RE: Braun Intertec
2637 Highway 14 West, HTE: 99-0879

REFERENCE: Building Permit Application #99-879 for the Braun Intertec Morton Building at 2637 Hwy 14 West.

Project: **Braun Intertec**
2637 Highway 14 West
App. No. 99-879

Thank you for your submittal and permit application for the above referenced project. A plan review has been performed based on the following general information:

INTERIOR LAYOUT

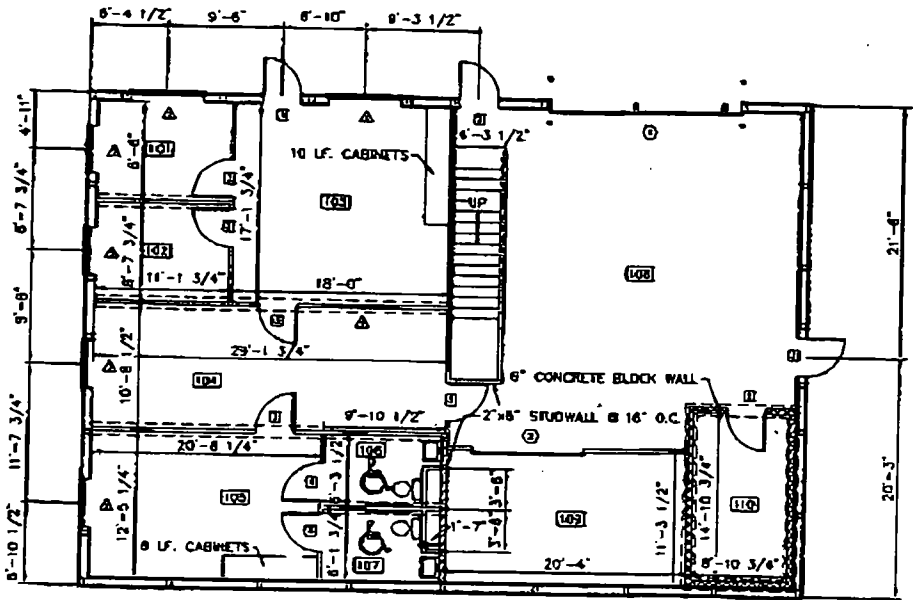
- 6 3 of 10 FINISH MATERIALS
Walls within water closet compartments and walls within 2 feet of the front and sides of urinals shall be finished to a height of 4 feet with materials which are not adversely affected by moisture.
--UBC Sec. 807.1.2

PART SHALL BE URETHANE BASE (POXY)
WITHIN 2'-0" ON TIME FRUIT & DEC. OF
THE WATER CLOSET TO A HEIGHT OF 4'-0"

RESTROOM CLEARANCE LAYOUT

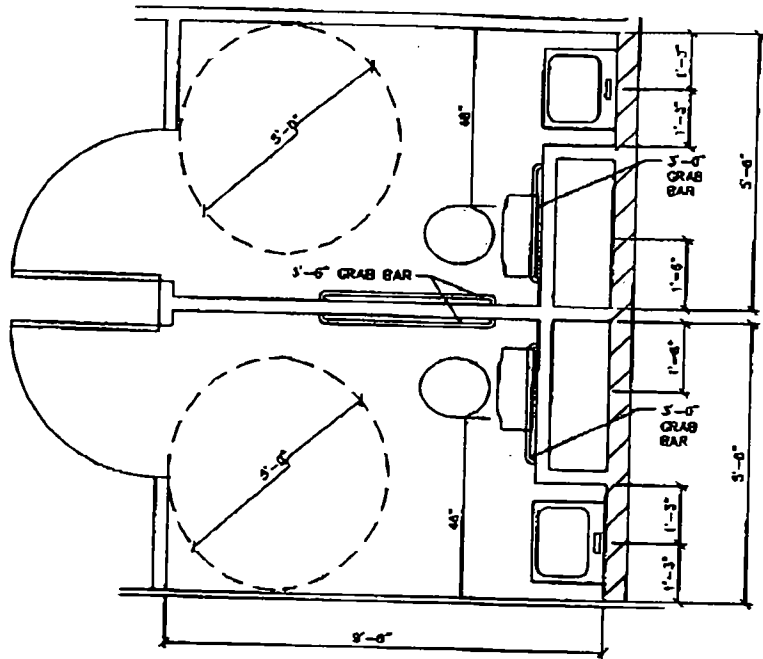
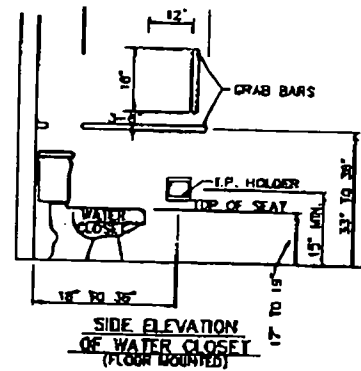
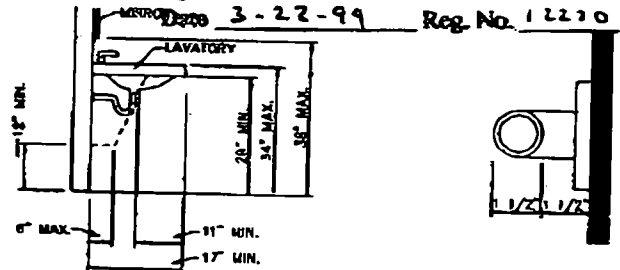
- 5 3 of 10, 4 of 10 WATER CLOSET CLEAR FLOOR SPACE REQUIREMENTS
A clear floor space for water closets shall be 48 inches in front of the water closet and 42 inches from the center line of the water closet on the side not adjacent to the wall. The lavatory appears to encroach into this required clear floor space. Please verify.
--M.R. 1340.1170 Subpart 1

1 HR. FIRE RATED SIDEWALL SECTION C-C
80 M.P.H. (EXP. 'C') WIND LOAD (U.L. NO. 10326) SCALE: 1/2" = 1'-0"

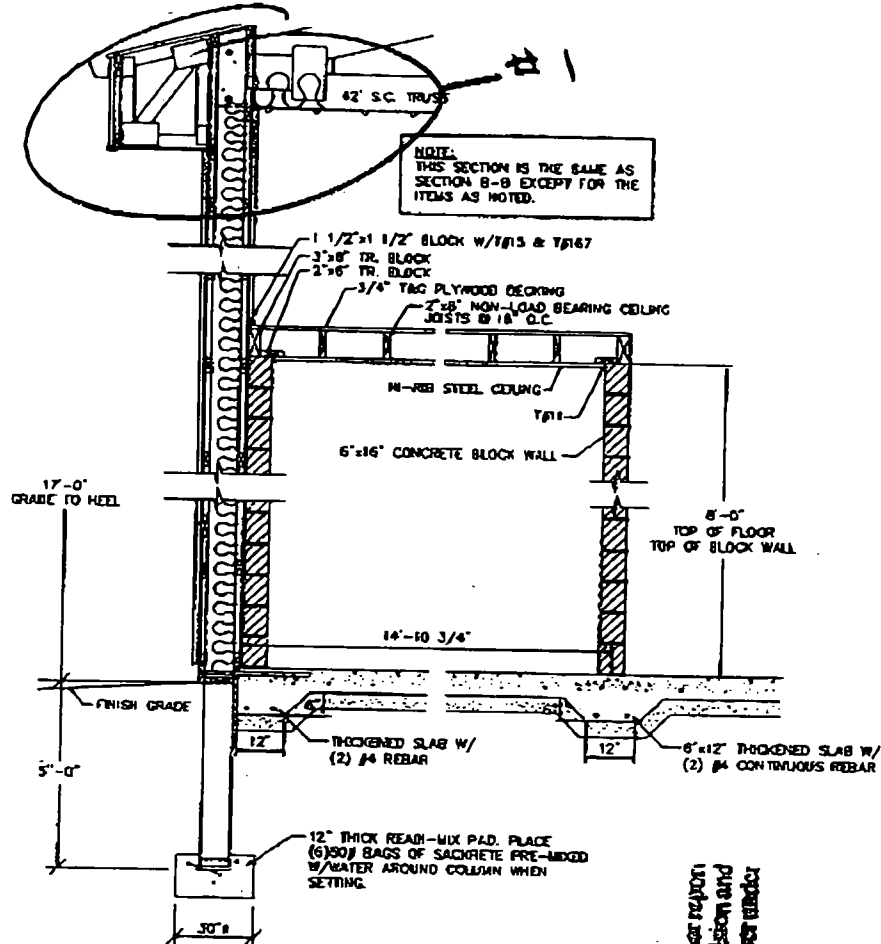
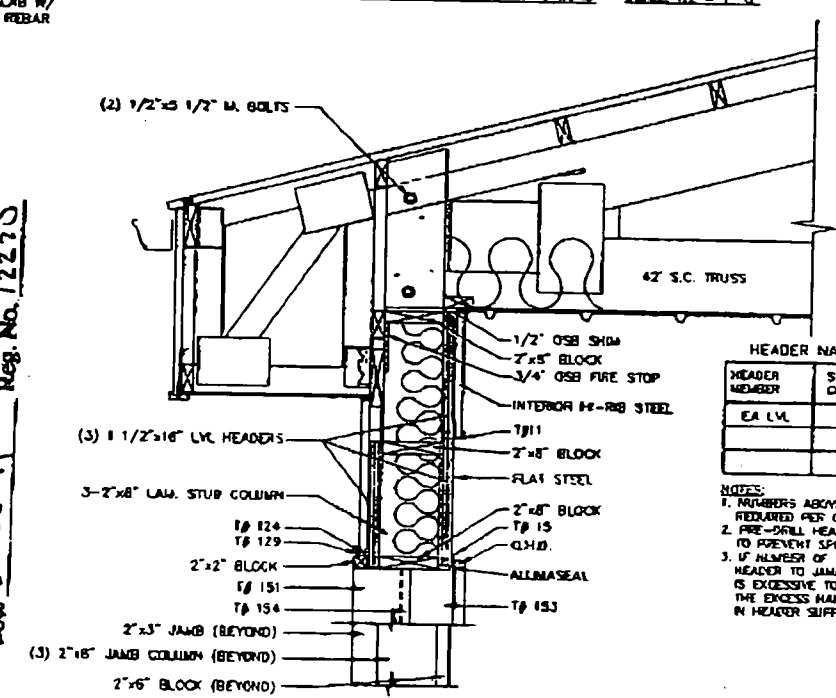
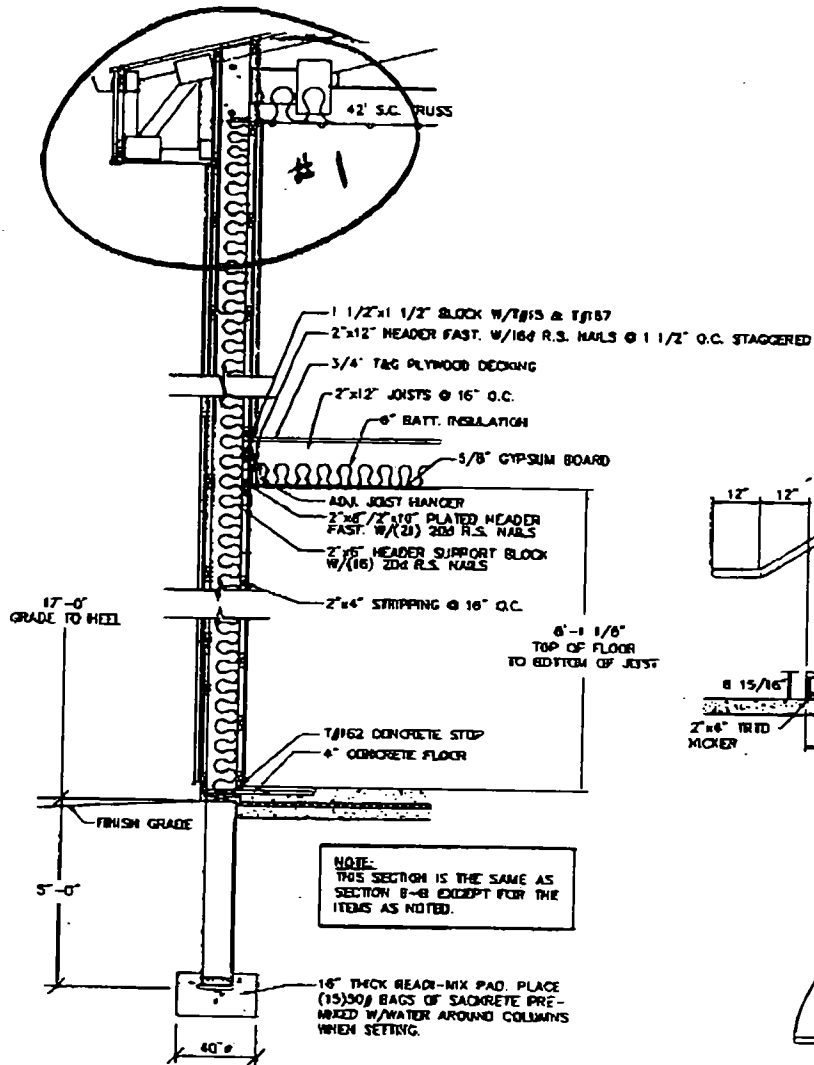
- 1 B/6, C/7, F/8 ONE-HOUR FIRE-RESISTIVE EXTERIOR WALL
In fire-resistive exterior wall construction, the fire-resistive rating shall be maintained for such walls passing through the attic areas or other areas containing concealed spaces. The one-hour fire-resistive construction shall be continuous to the roof deck.
--UBC Sec. 709.3.1

STAIR SECTION G-G

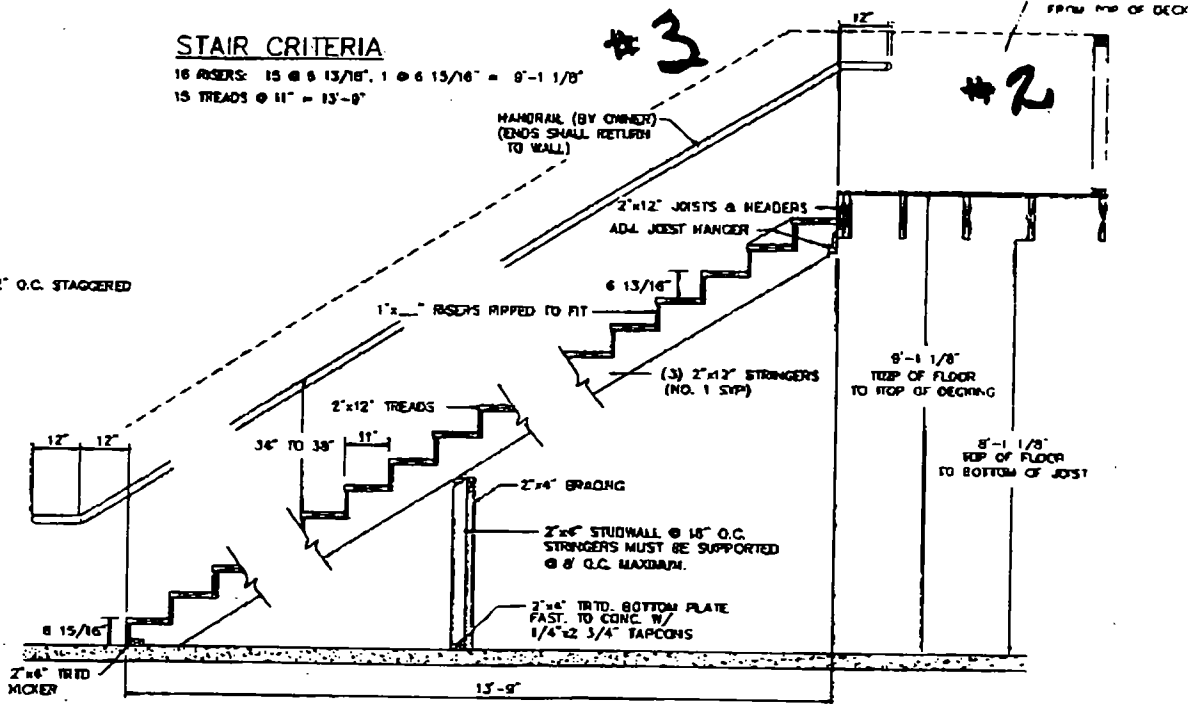
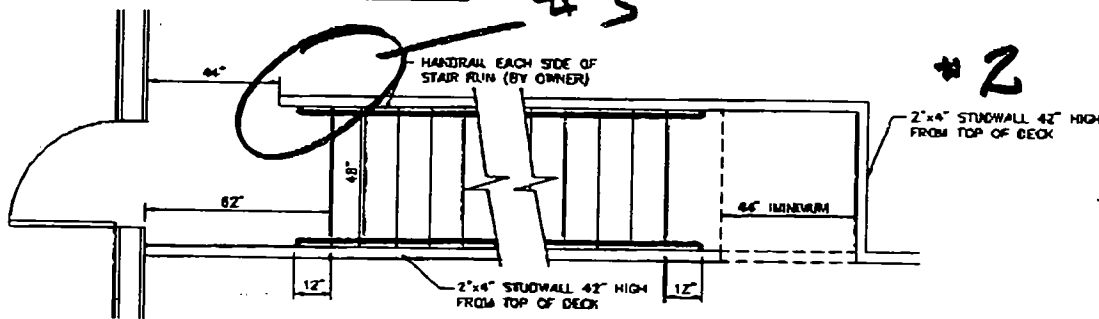
- 3 G/8 STAIR HANDRAILS AND GUARDRAIL
All stairways shall be provided with handrails and guardrails in accordance with the referenced code sections. The handrail and guardrail details do not meet these requirements. Please verify and provide revised details.
--UBC Sec. 304.4, 311.4, 1003.3.3.6, 1003.3.3.7, 509, CABO/ANSI Sec. 4.3.10, 4.3.11

- 4 G/8 STAIR NOSINGS
The stair nosing shall be rounded in accordance with the referenced code section. Please verify.
--CABO/ANSI Sec. 4.9.3 (Lateral nosing can be secured by ~~rod~~ in accessible)
